### 3. Other design-amendments – 2 of 2

Revised front-elevation

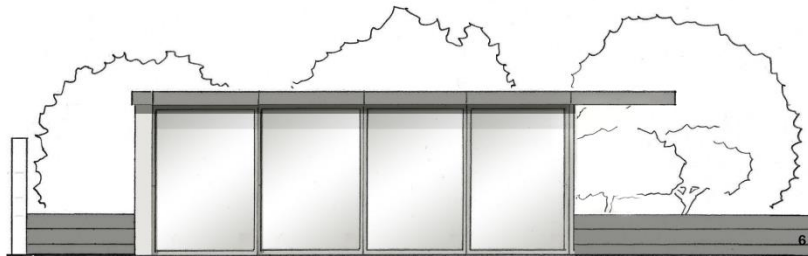
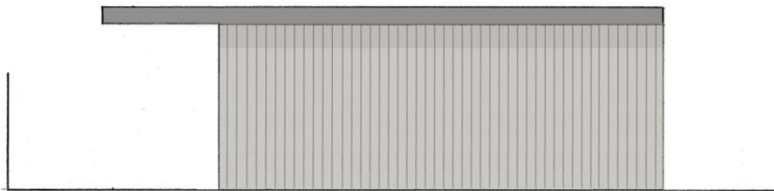
*On top of a reduction in size, some design tweaks could help a garden building to recede better, and address the CAAC's concerns – the glazing could be set further back under the roofline on the diagonal front, **the proposed soffit of the eaves should appear darker than it does in the D&AS visualisation, and the drawings should give a better idea of the size and detailing of the stained timber cladding to the walls.***

2. We increased the colour-contrast between the external walls' cladding and the soffit:

The walls are clad in a light grey wash.

The soffit is clad in an anthracite wash.
